## UNITED STATES ENVIRONMENTAL PROTECTION AGENCY

RE: Western Tar Products
Terre Haute, Indiana

U.S. EPA has reviewed your recent submittal to IDEM, Remediation Work Plan (RWP) for Western Tar (Railworks) facility – Process Area dated May 13, 2010, and IDEM's technical review of the RWP dated August 17, 2010. U.S.EPA has reevaluated our e-mail dated March 18, 2010, and proposes the following phased approach:

1. Approximate locations of U.S.EPA Proposed Test Pits and Borings

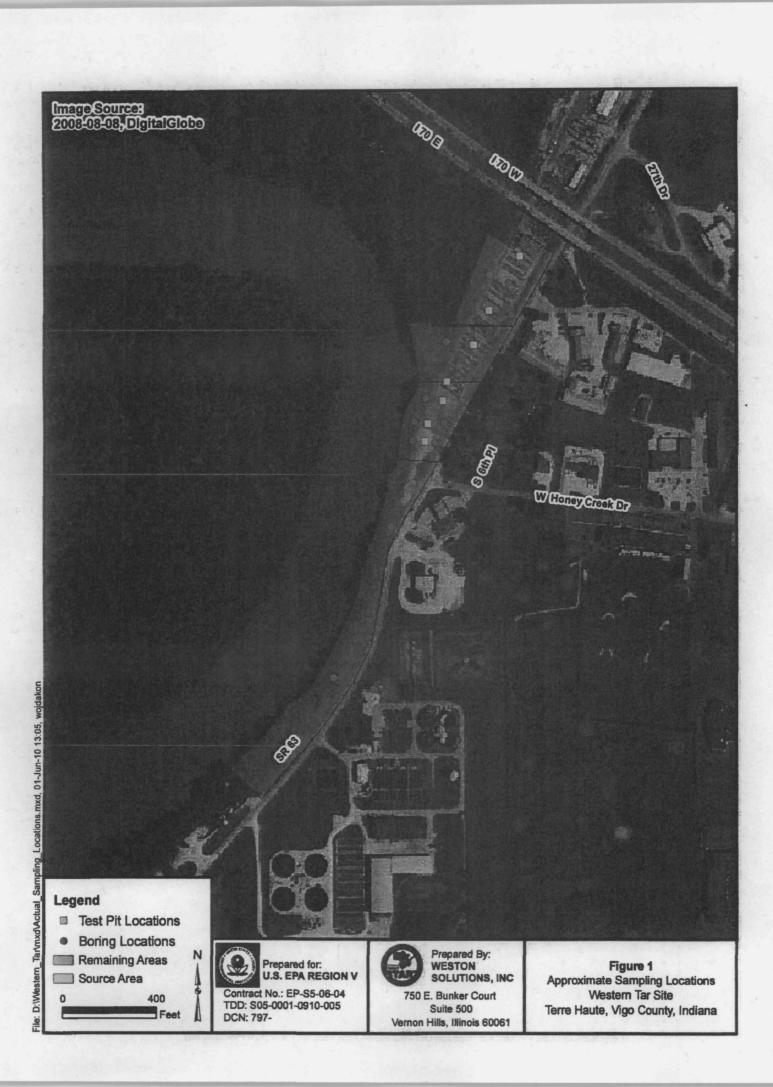
- 1. 7 test pits (Test pits extended to a depth of 6 feet);
- 2. 13 borings at least 5 feet below the water table;
- 3. Sampling in the Wabash River, if the river is low, otherwise, this can be done after the Indiana Bat season or concurrent with remediation;
- 4. Final report for 1-3;
- 5. Remediation based on review of #4.
